THORN RUN WATERSHED TMDL

TMDLs
Thorn Run Watershed
Westmoreland County, PA

Comment and Response

January 18, 2001 comments form Region III, EPA for Thorn Run:

Thorn Run Creek Watershed Map

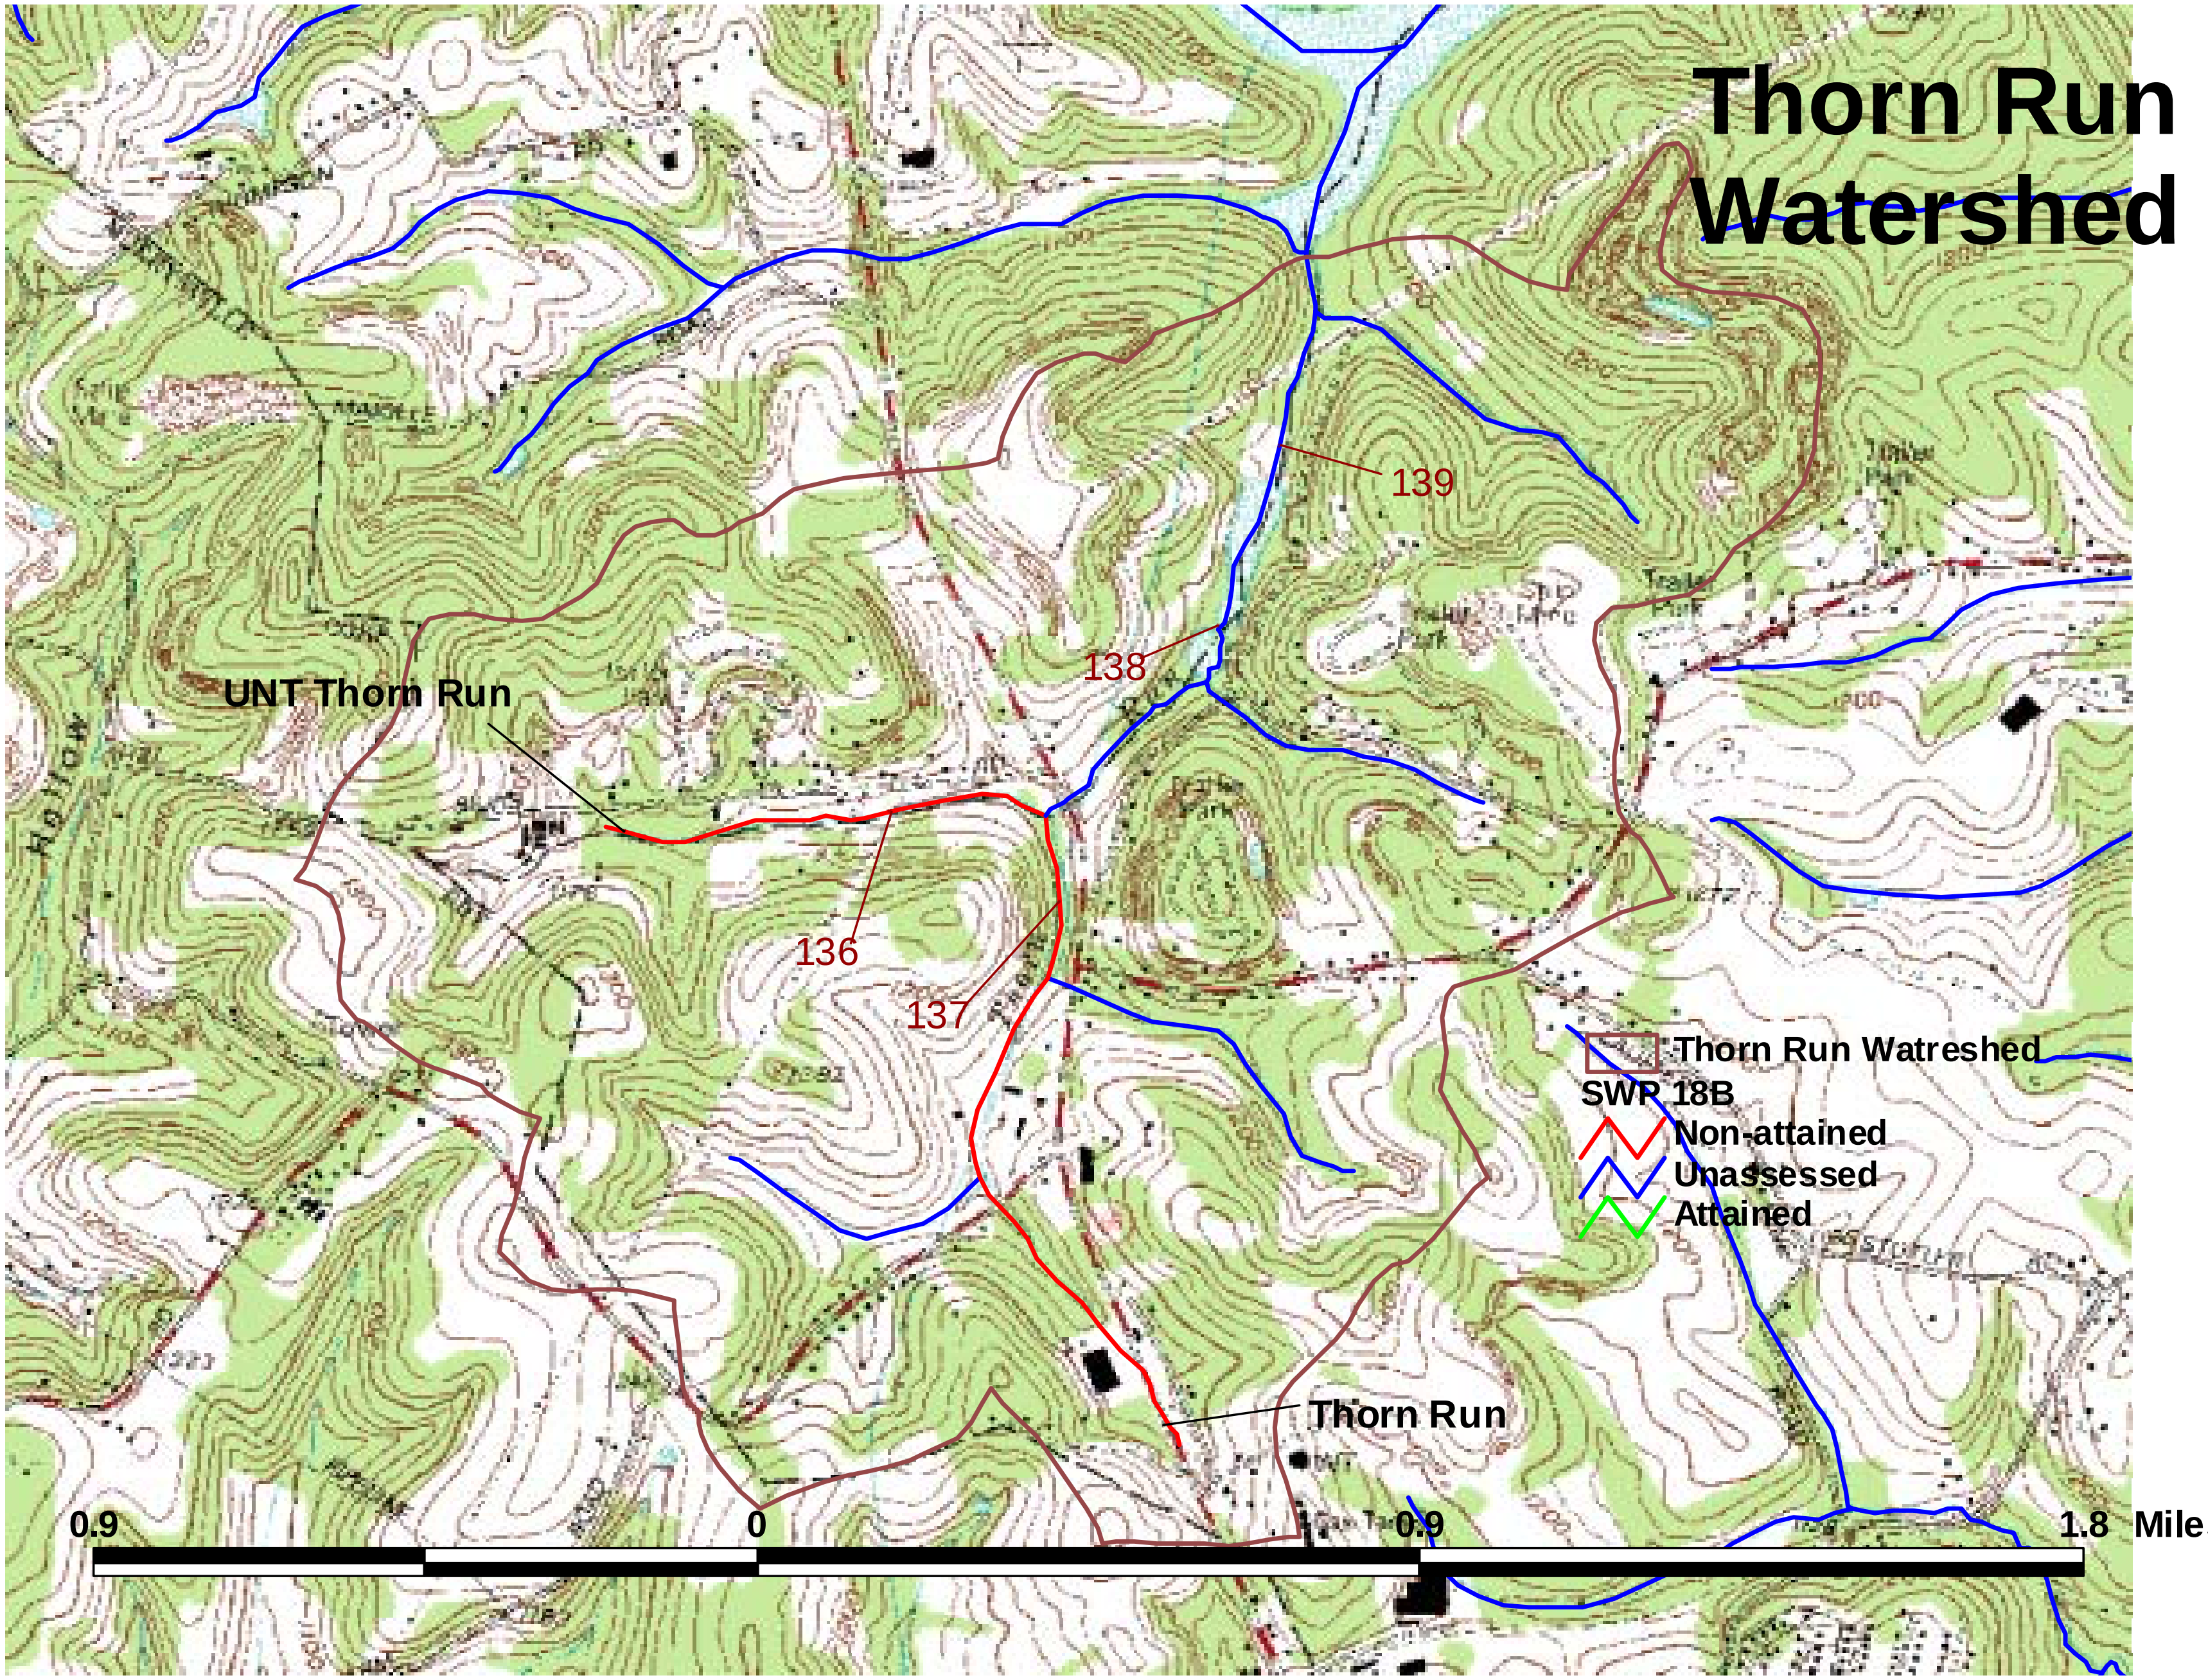
Please identify the TMDL values for the segments listed on the 1996, 303(d) list, e.g. Segment ID 4998 and 4999. This will fulfill the requirement that each water quality impaired segment listed on the section 303(d) list have its own TMDL.

Describe the reservoir at site 138. DeLorme's Topos USA describe the stream downstream of the reservoir as intermittent, therefore, using the downstream sampling points one measured flow may not be appropriate. Examination of metal concentrations at 138 and 139 indicates the possibility of metals, together with sediment, is settling to the bottom of the reservoir. Confirm whether or not site 138 is located on a water-quality limited segment listing on the 1996 section of 303(d) list or any subsequent list. If not, data presented in Data Table 3 suggest it should be listed on the next section 303(d) list.

Thorn Run, 4998, and the UNT Thorn Run, 4999, have been identified on the maps and within the TMDL report in the appropriate places (example see Table 1 on page 2).

The “reservoirs” in question are former mine treatment ponds. Thorn Run between the treatment ponds and north of the last one is a perennial stream not intermittent. In fact there is a wetlands area downstream, north, of the treatment ponds.

Thorn Run downstream of the UNT Thorn Run, stream code 42977, is not on the 1996 303(d) list. The UNT Thorn Run and the portion of Thorn Run upstream of the UNT are on the 1996 303(d) list, segment id’s 4998 and 4999. In fact Thorn Run downstream of the UNT is unassessed and will be assessed as part of the Departments Unassessed Waters program.
